- Description of Request: Variance for sign area on front and rear elevations because murals are considered signs and a mural on each elevation is proposed.

STAFF REPORT

APPLICANT: BJ's Restaurants, Inc.

LOCATION: Future 1.25 acre lot fronting on Mall Circle Road and Plaza Boulevard and located immediately to the east of 7848 Mall Road, Florence, Kentucky

FRONT/NORTH ELEVATION SIGN LOCATION

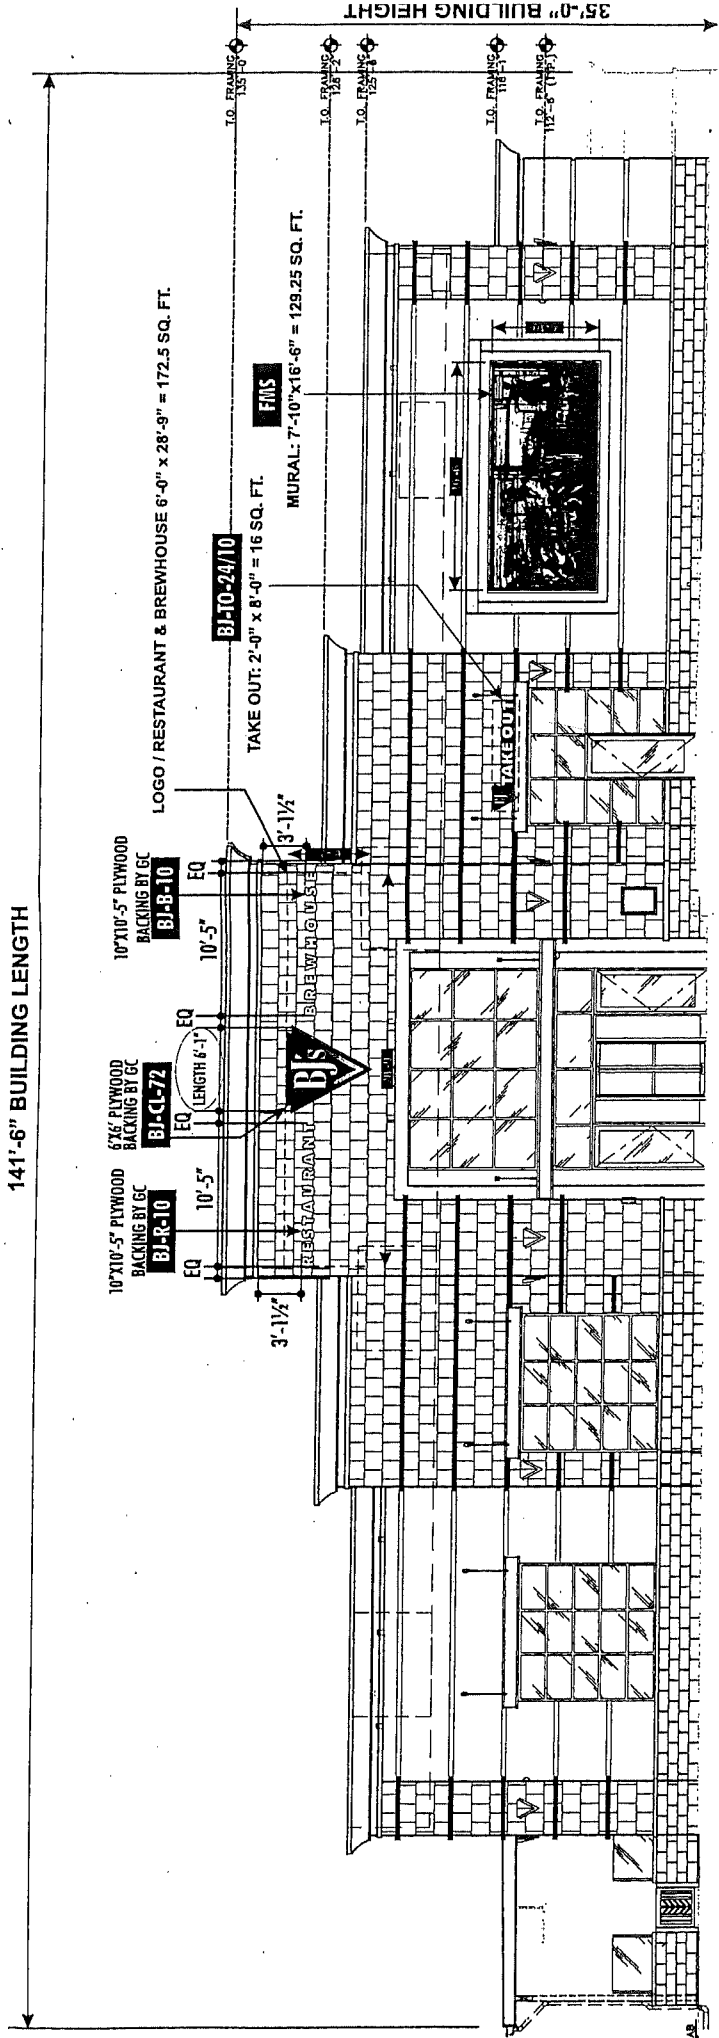
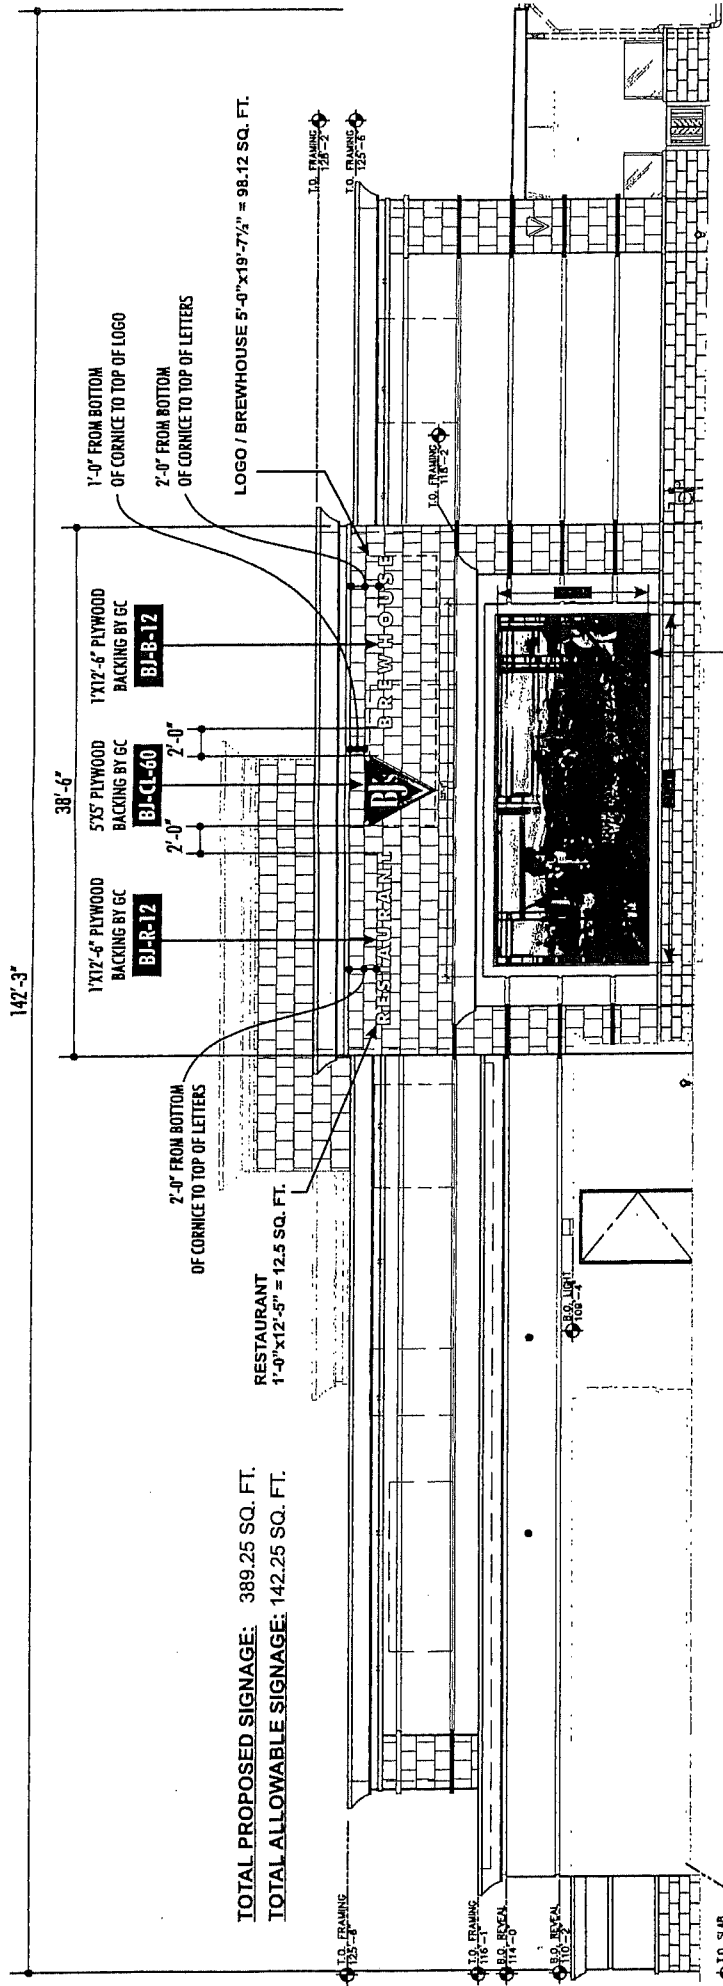
3. The proposed signage on the front facade exceeds code by 34.75 square feet (283 square feet allowed and 317.75 square feet proposed). Staff does not believe the mural looks out of place as proposed.

- A. The proposed murals shall be maintained as presented to the Board; or
- B. Any changes in the composition of either mural shall be reviewed by the Board through the formal Variance procedure to insure that an integral design relationship is maintained between the murals and the building; or
- C. Either or both murals may be removed and the remaining wall area(s) shall be finished in a rose limestone veneer which matches the surrounding wall areas in terms of color, texture, shape, size, and finish.

REAR ELEVATION

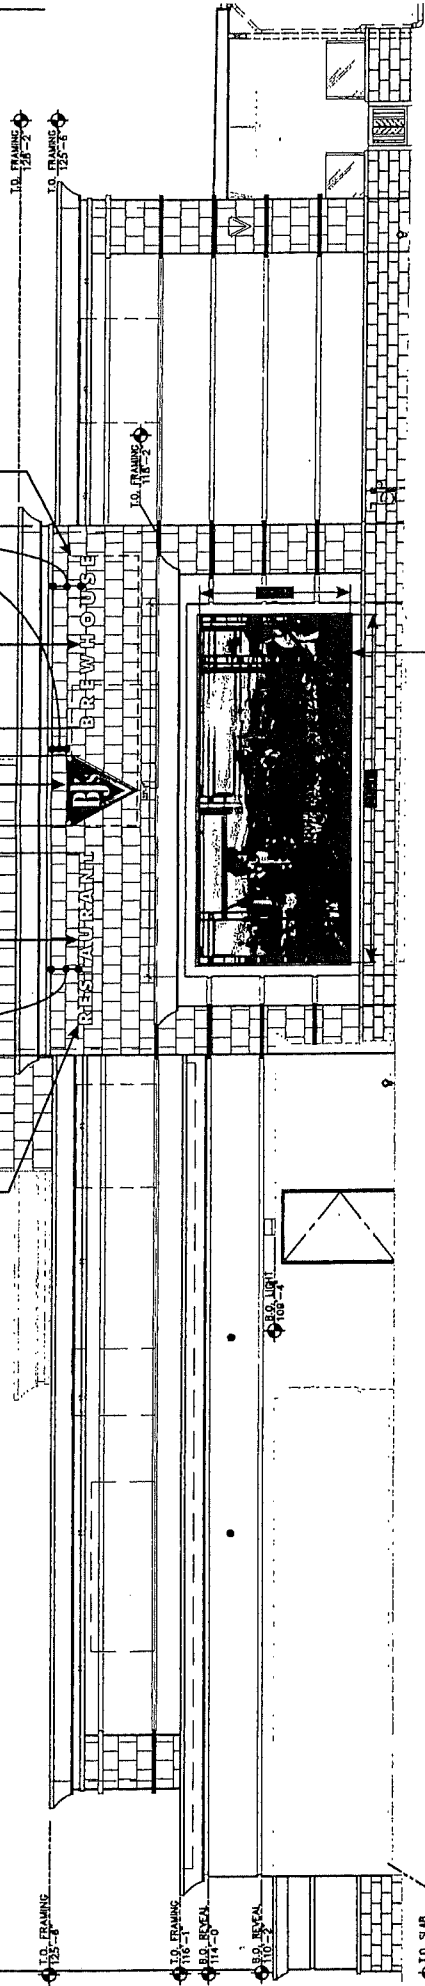
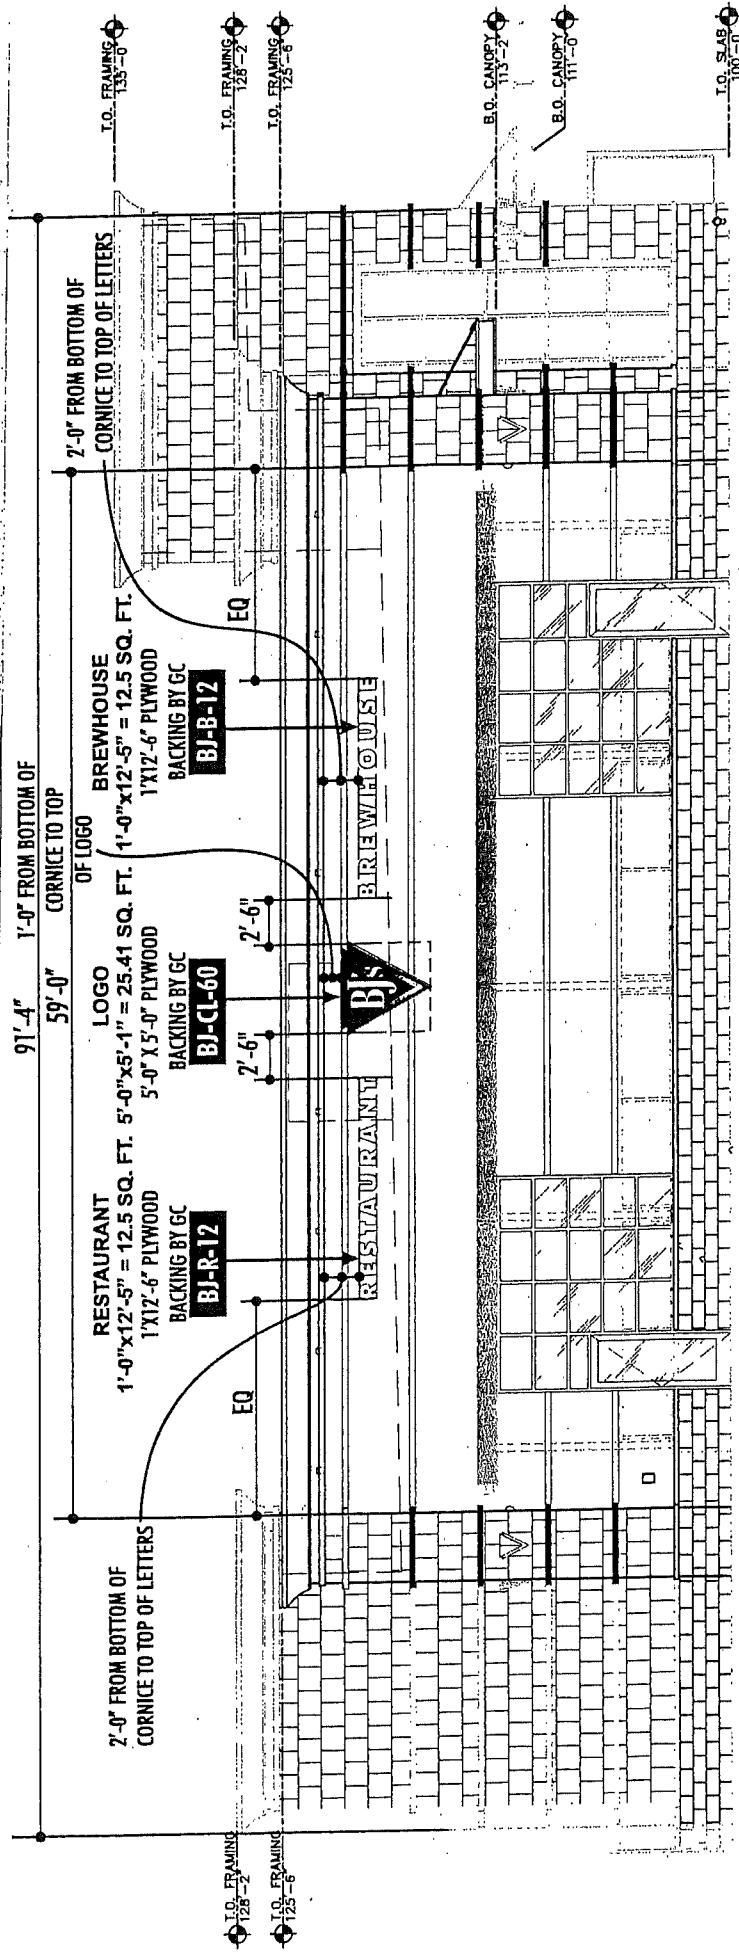
4. The proposed signage on the rear facade exceeds code by 247 square feet (142.25 square feet allowed and 389.25 proposed). Staff questions the location of the large mural on this facade because it will be hung over the loading zone for the building. The architectural design requirements of the Mall Road District Study state that loading/unloading/service areas "shall be enclosed with a screen wall which is at least 8 feet high and which uses the same materials, colors, and design detailing as the building which it serves. Alternatively, dense landscape hedging which will provide year round screening and that will grow to at least 8 feet high without routinely overtaking the planting space may be considered."
